# PLANNING

RED NOTES/ SHOW AMENDMENTS TO ORIGINAL PLANNING APPLICATION

1 Proposed Ground Floor Plan  
Scale: 1:100

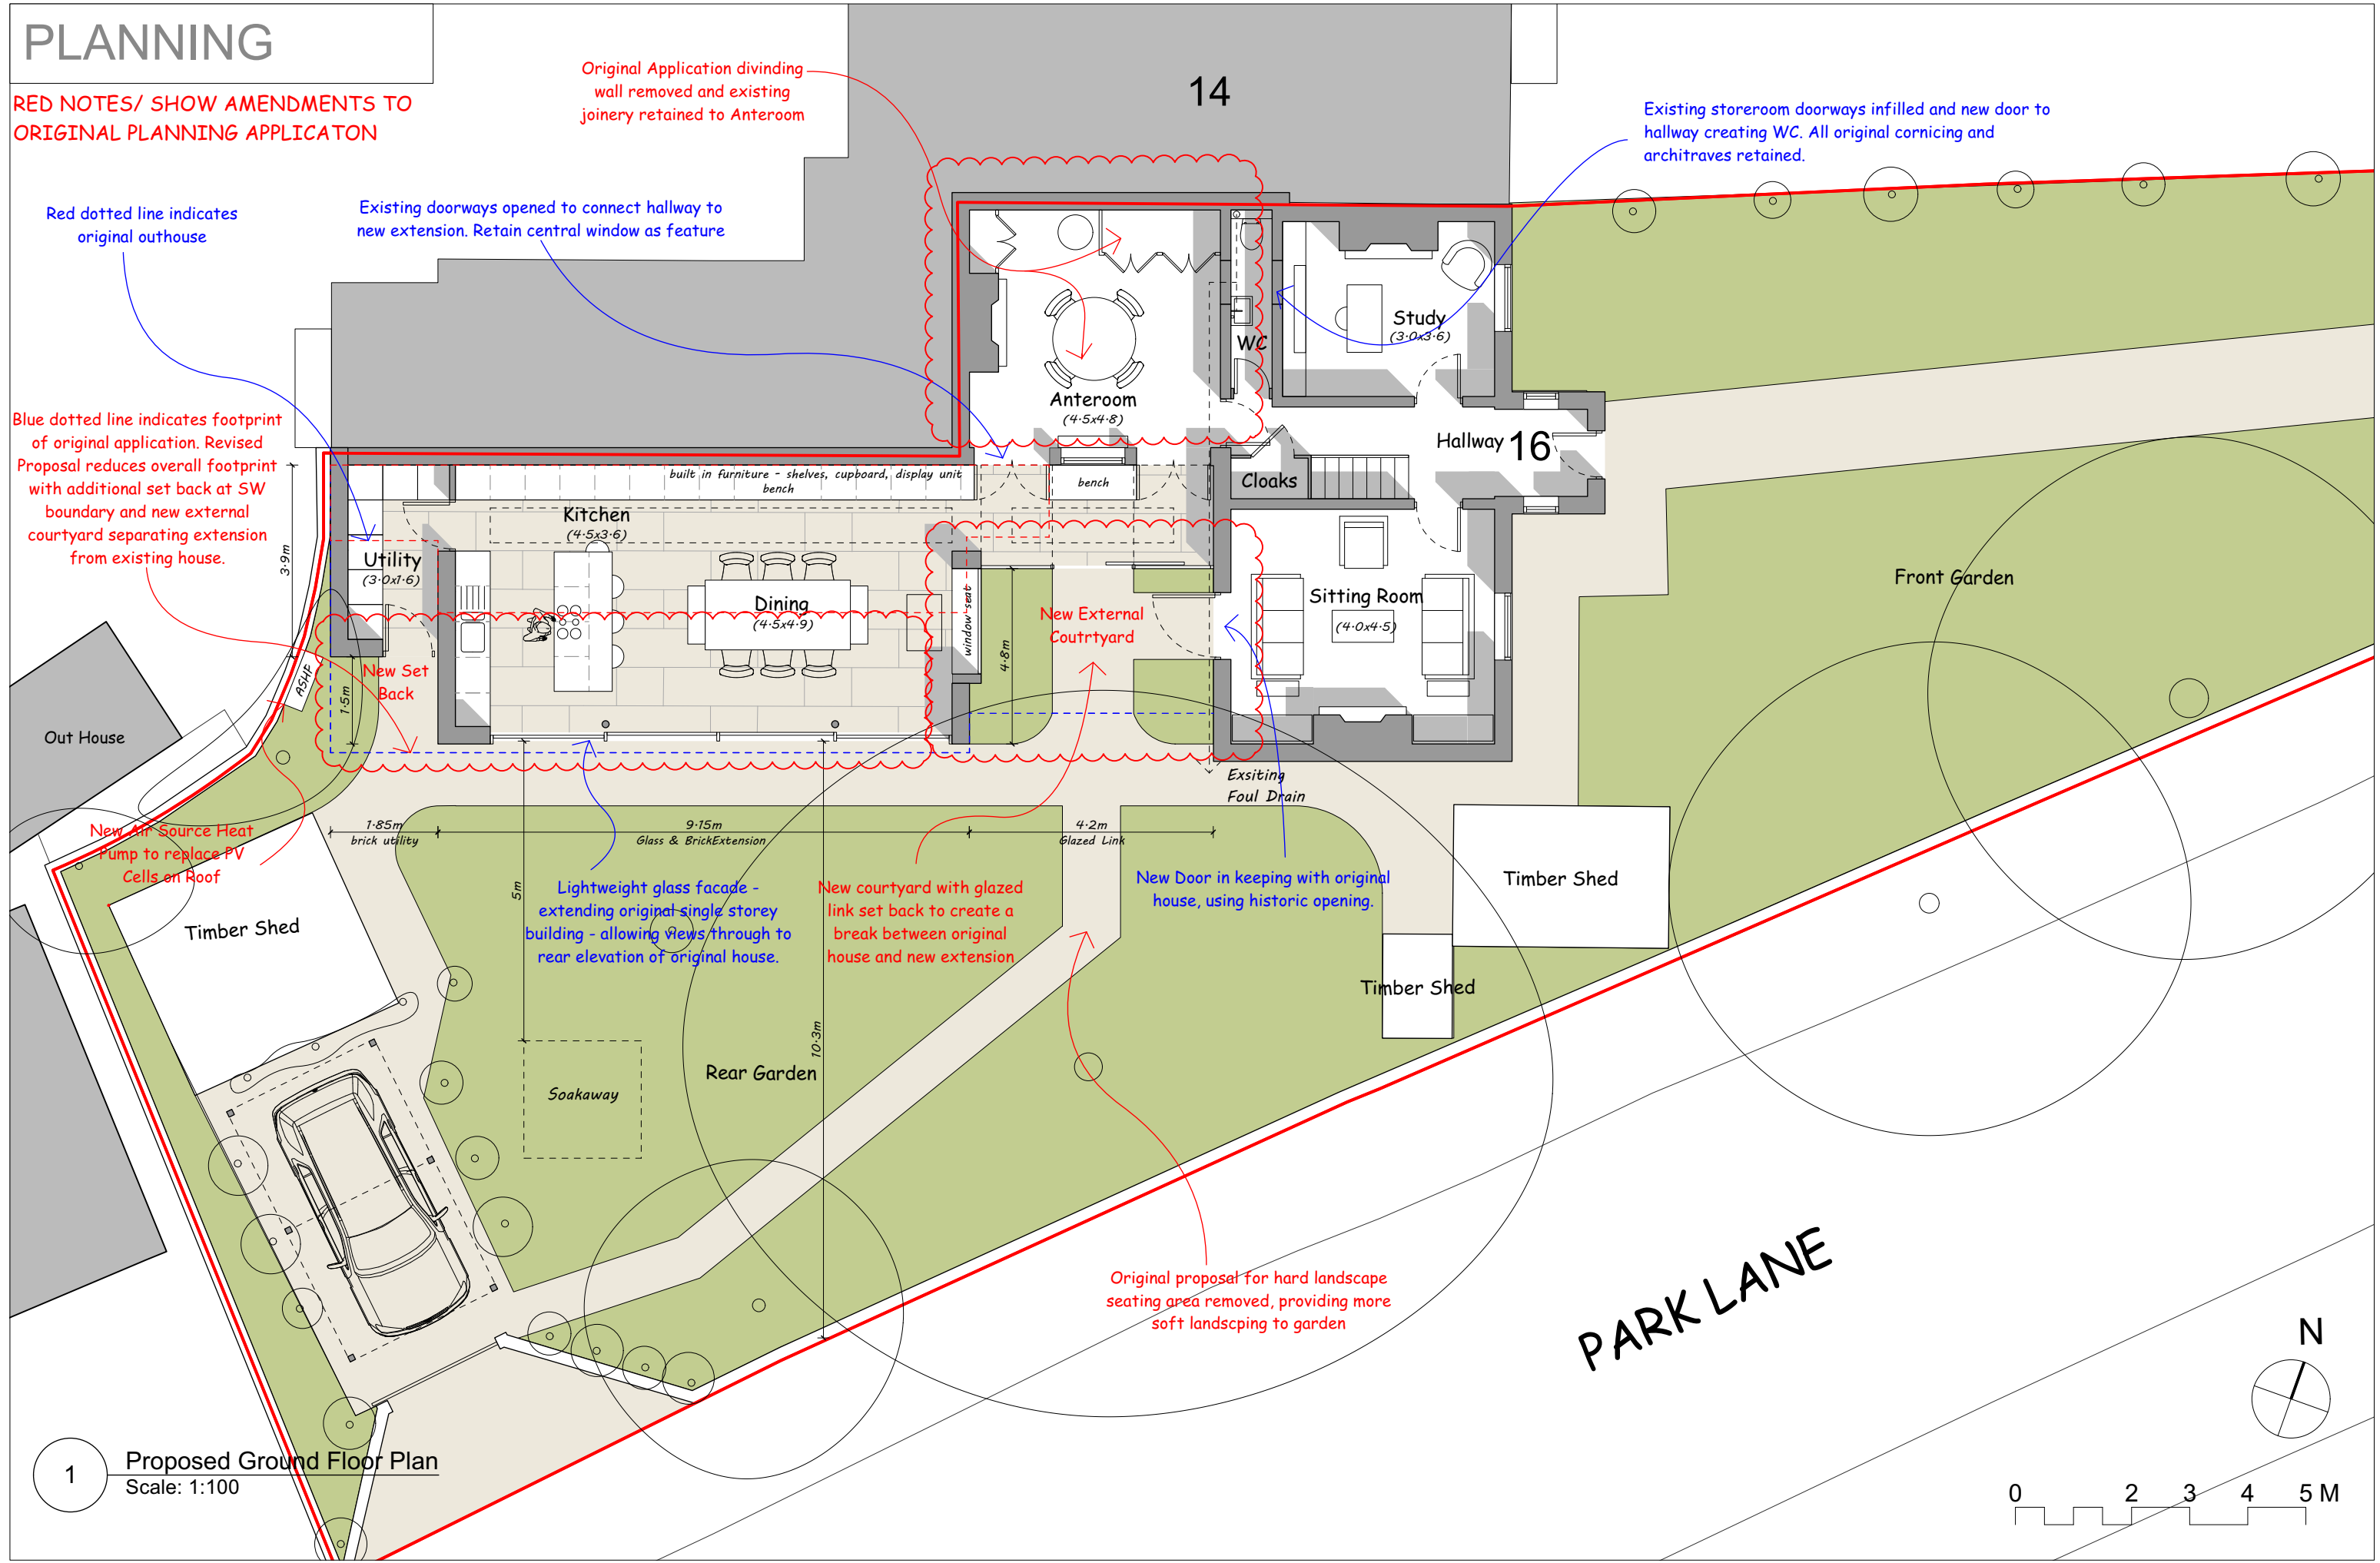
Red dotted line indicates original outhouse

Existing doorways opened to connect hallway to new extension. Retain central window as feature

Original Application dividing wall removed and existing joinery retained to Anteroom

Existing storeroom doorways infilled and new door to hallway creating WC. All original corning and architraves retained.

Blue dotted line indicates footprint of original application. Revised Proposal reduces overall footprint with additional set back at SW boundary and new external courtyard separating extension from existing house.
